Town of Enfield

BLACK OAK WIND FARM

**Supplemental Draft Environmental
Impact Statement**

Written Public Comments

Black Oak Wind Farm
 Towns of Enfield and Newfield, Tompkins County
Figure 1: Project Layout Comparison
 January 2016

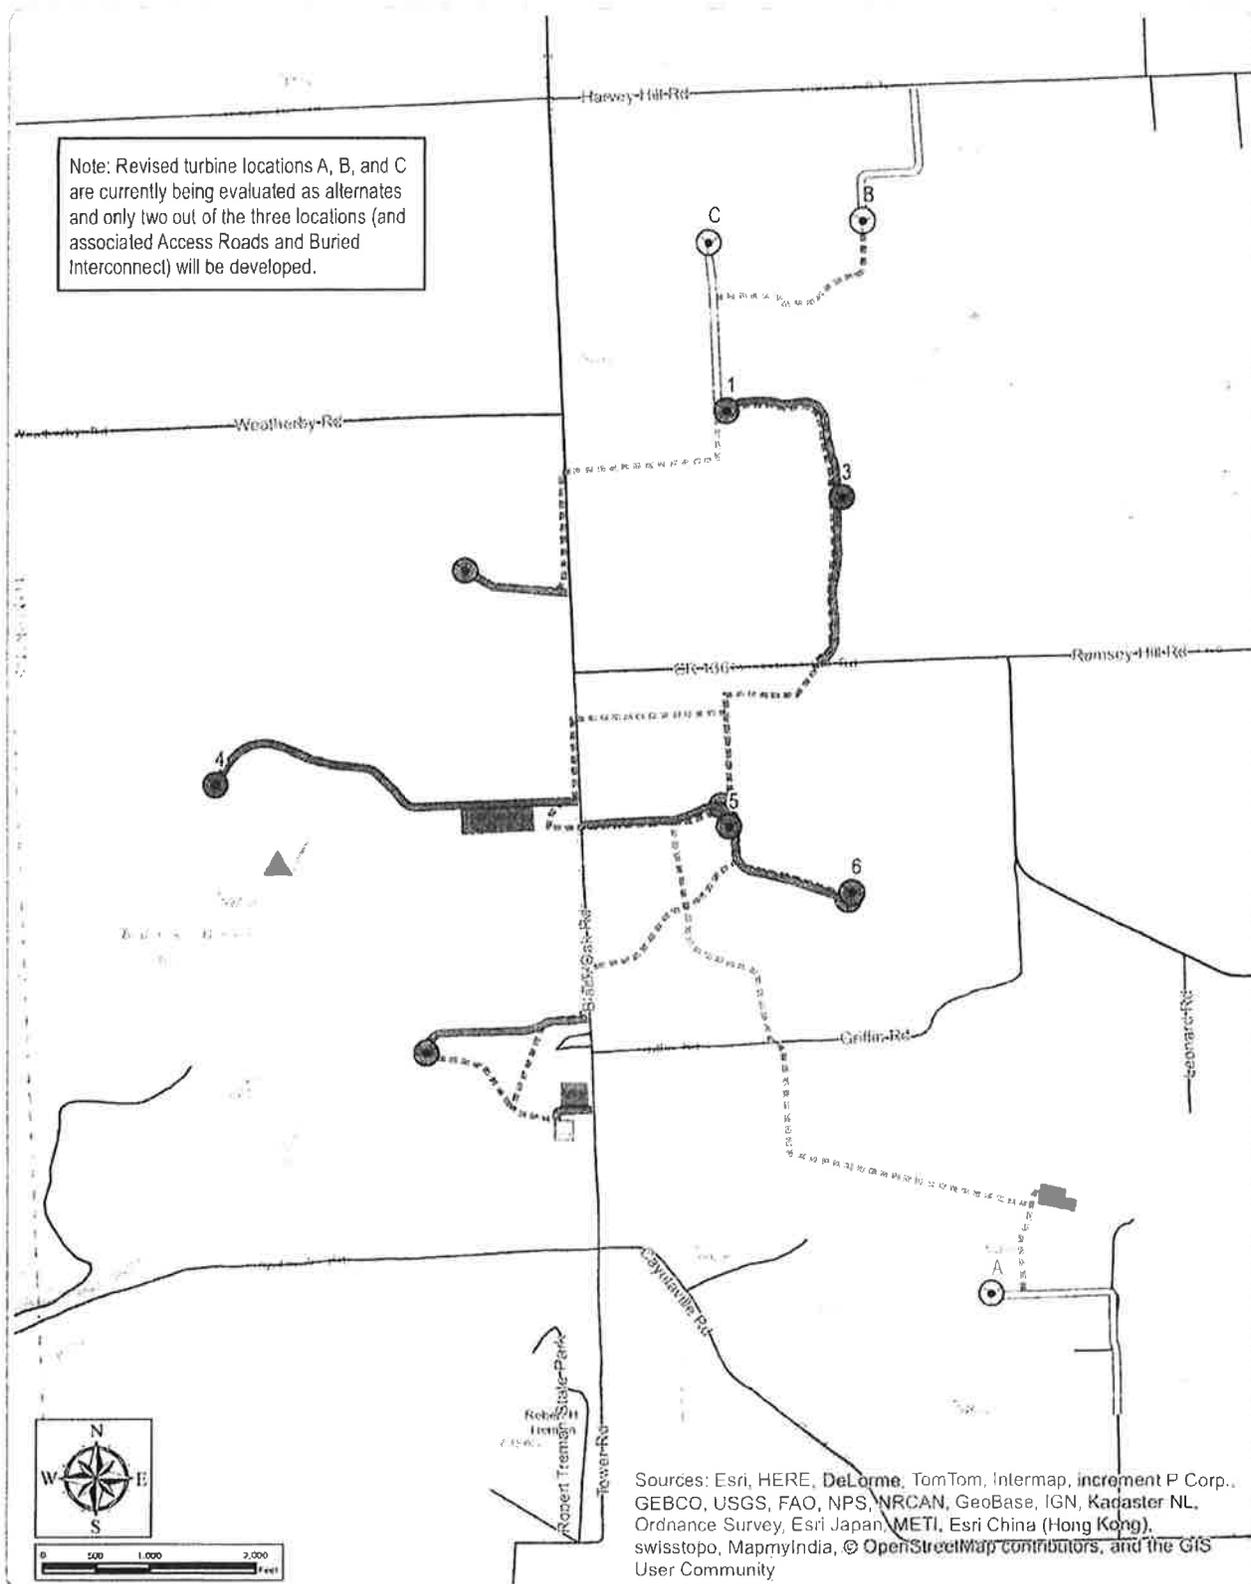
The changes listed on page 2 outlining the modifications in the Modified Project fail to include the movements of Turbines 1, 3, 4, and 6 outlined below. Furthermore, Turbine 5 has been moved a total of 219 feet, not the 160 feet indicated in the SEIS. These distances were calculated by comparing the locations of the turbines in Figure 5 of the SEIS with the locations of the corresponding turbines in the 4 pages of Figure 4 of the FEIS. GIS software was used to calculate the change in location. This work was done by Stone Environmental in Montpelier, Vermont. (See attached letter from Stone Environmental - Exhibit 2.)

Looking at Figure 1, it is difficult to ascertain what changes are being made in the collection lines between Turbines 4 and 5 and between Turbines 5 and 6.

26. The labelling on Figure 1 in Appendix B is confusing. What is FEIS Collection Line, Alternate Collection, FEIS Access Road, Alternate Access? It is difficult to visually distinguish between FEIS Access Road and Alternate Access, and in general it would be easier to follow these maps if they were on an aerial photo base, a USGS base, or had additional landmarks.

Figure 1: Approximate Measurement Locations

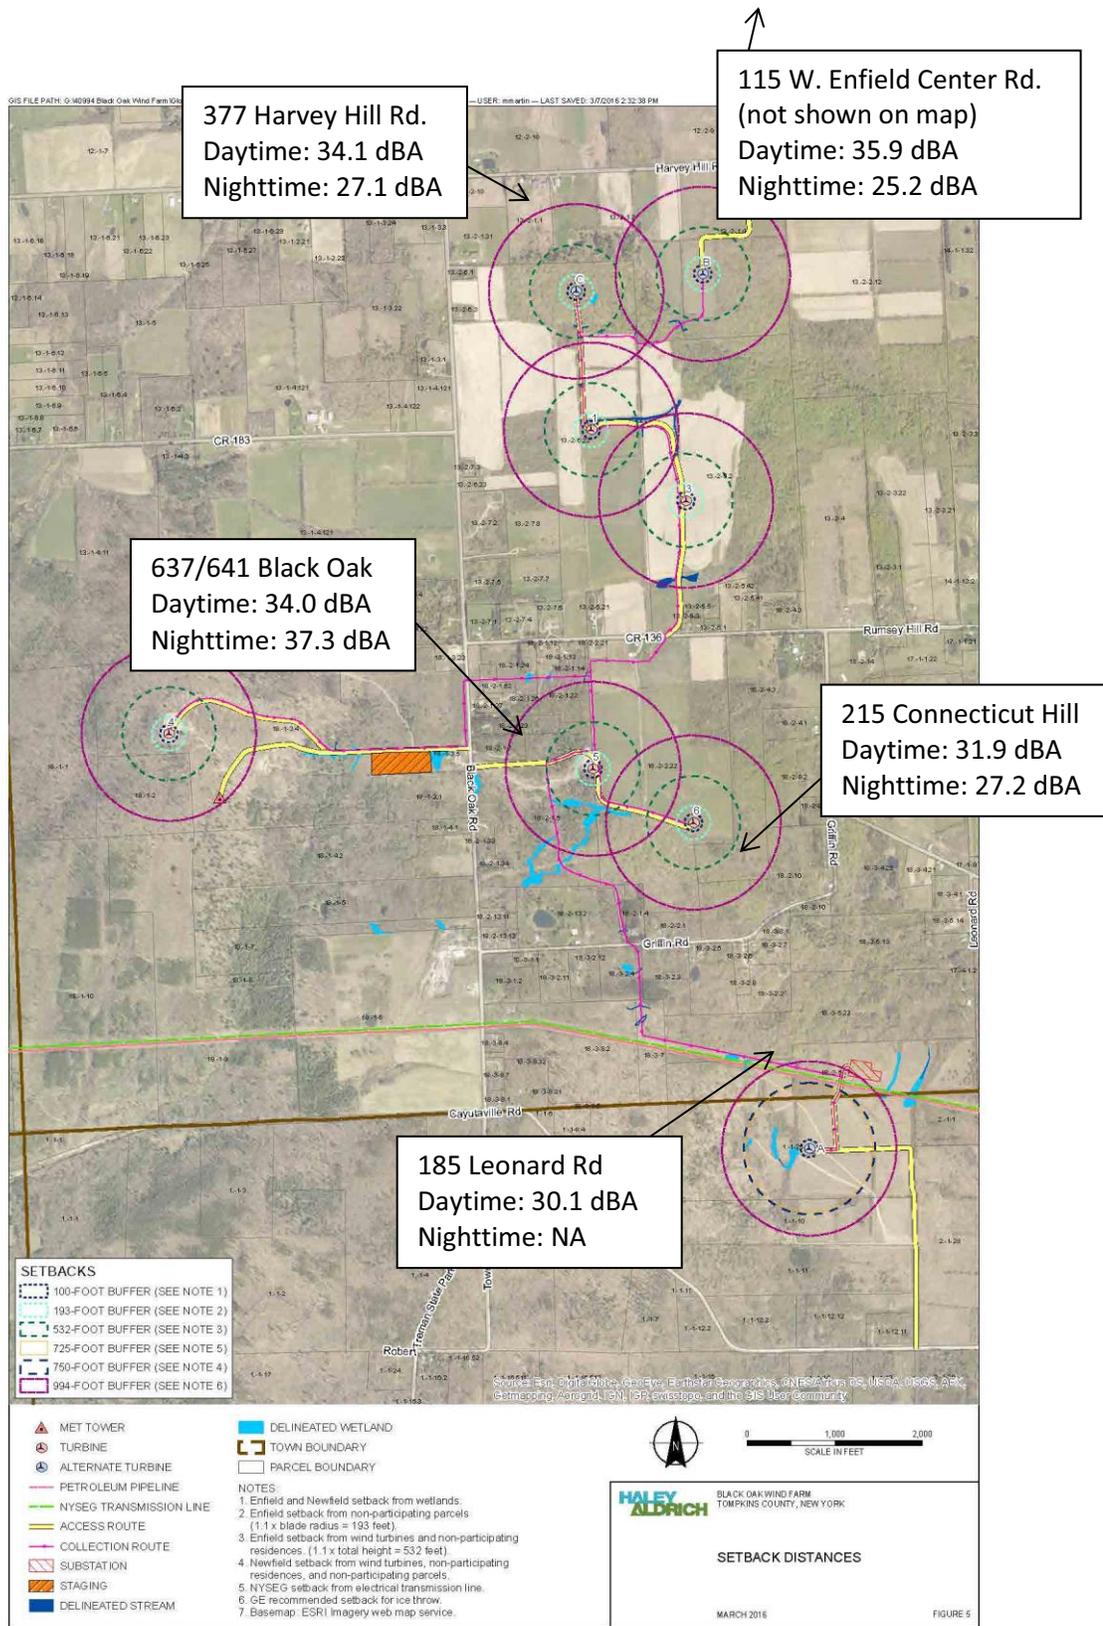
Figure 1 shows the locations of the noise measurements. The locations and noise Leq ambient levels are shown superimposed on Figure 5 of the DSEIS.

Figure 9. Predicted Noise Levels at the Property Line near Turbine C.

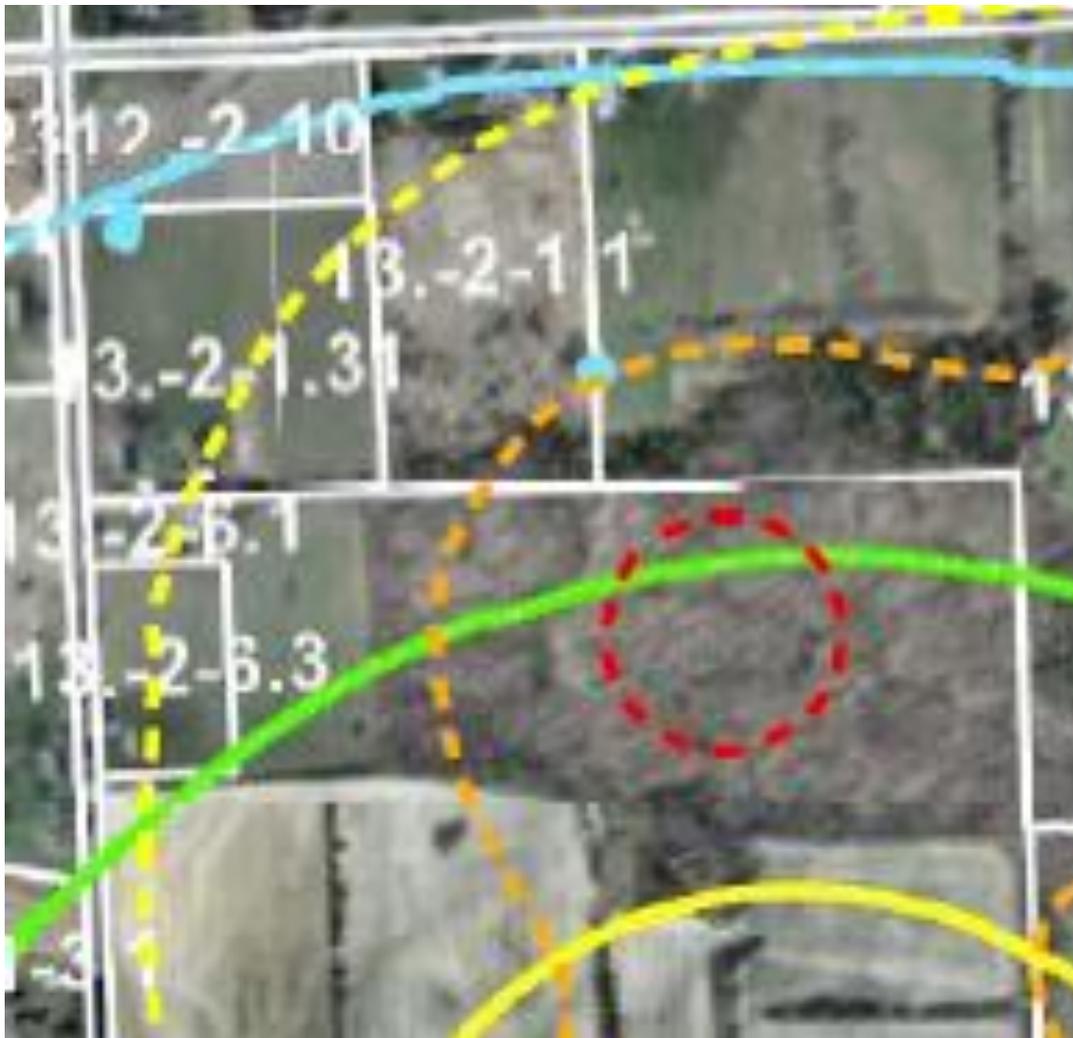
Figure 9 shows the predicted noise levels near Turbine C (not shown but inside the dashed red circle). It is a composite of Figure 3 from Appendix H of the DSEIS (the dotted contour lines) and Figure 2 of Appendix T of the FEIS (the solid contour lines). According to the legends of these Figures, the red line corresponds to the 55 dBA level; the orange, to the 50 dBA level. The property lines are shown in white. The orange dotted line representing 50 dBA from the DSEIS turbine configuration clearly crosses the property line northwest of Turbine C in Figure 9 marked 13.-2-1.1. This location is intended as a home site for the homeowners children, for which it would not be suitable if it were built.

Figure 10. Predicted Noise Levels at the Property Line near Turbine A.

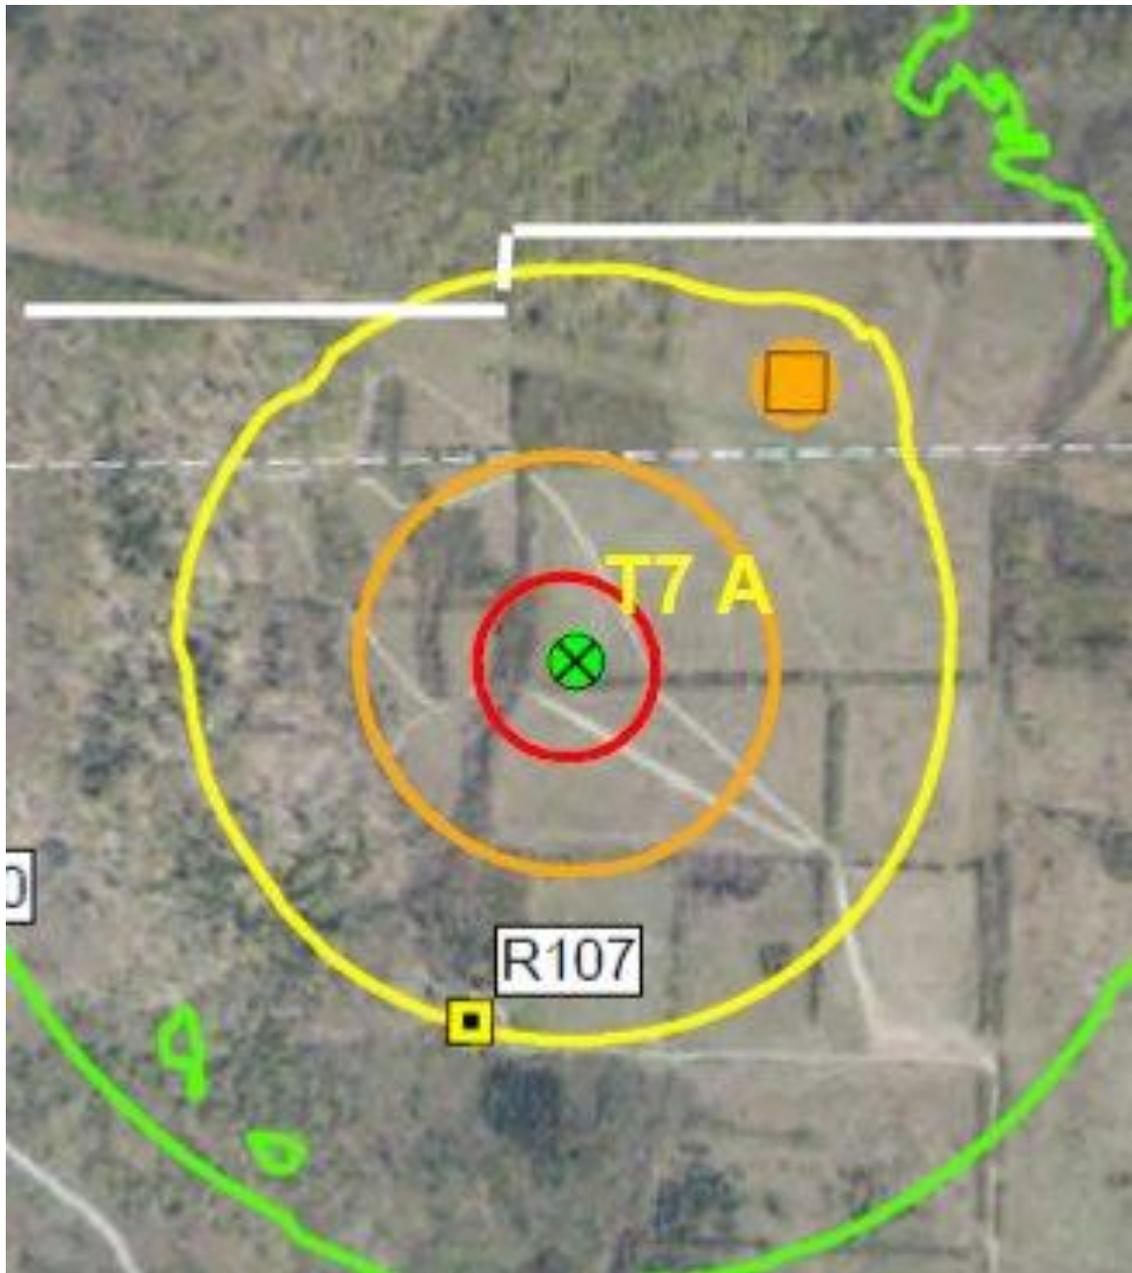
Figure 10 shows the predicted property line noise levels north of Turbine A from Figure 2 of the DSEIS Appendix H. The white property line of a non-participating neighbor has been added. From the figure one can see that the noise levels approach and exceed 45 dBA in this area. There is what the home owner calls his “second field” in this vicinity. It is a maintained grassy area with a structure.

Figure 13. Predicted Noise Levels from the DSEIS and FEIS.

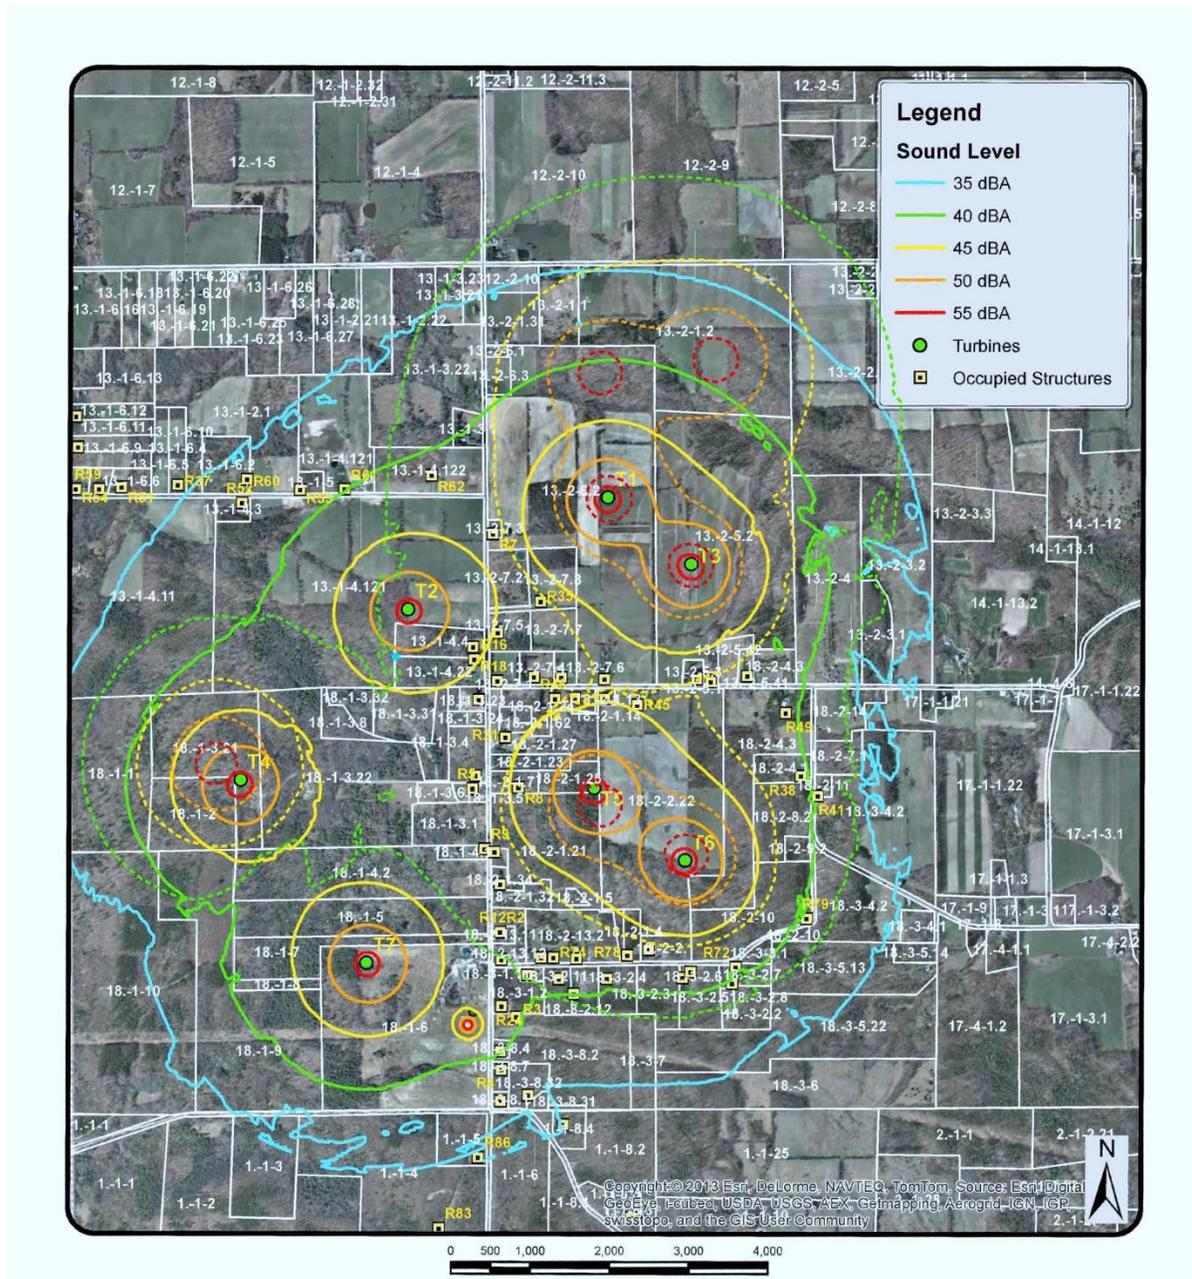
Figure 13 shows the predicted noise of the DSEIS and FEIS. It is a composite of Figure 3 from Appendix H of the DSEIS and Figure 2 of Appendix T of the FEIS. The dashed contour lines are the noise levels from the DSEIS. They are superimposed on top of the map from the FEIS and its solid contour lines. According to the legends of these Figures, the red line corresponds to the 55 dBA level; the orange, to the 50 dBA level; the yellow, to the 45 dBA level; and the green, to the 40 dBA level. The property lines are shown in white. Similar maps could be made for the other turbine configurations in the DSEIS.

1. The total area of noise impacted land is much greater in the DSEIS. This can be seen from the map, and also from analysis of the map. Figure 14 below describes percent increase in lands above 55 dBA, 50 dBA, and 45 dBA.

Figure 1: Approximate Measurement Locations

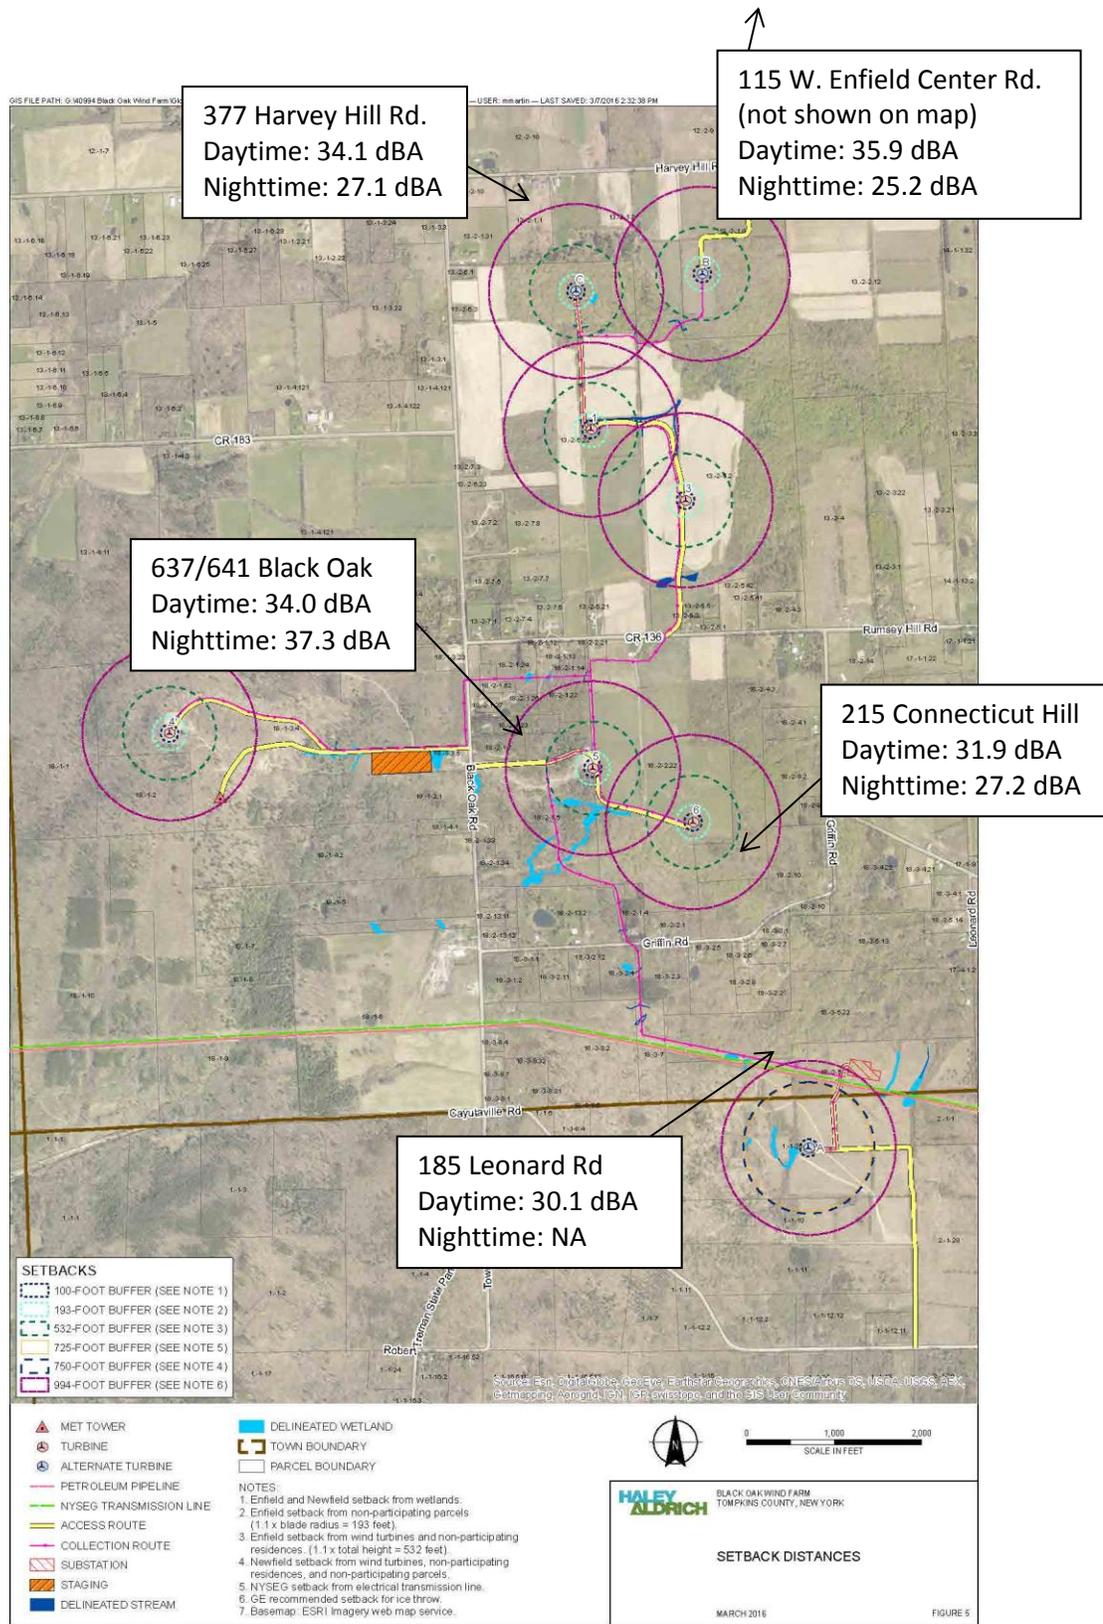
Figure 1 shows the locations of the noise measurements. The locations and noise Leq ambient levels are shown superimposed on Figure 5 of the DSEIS.
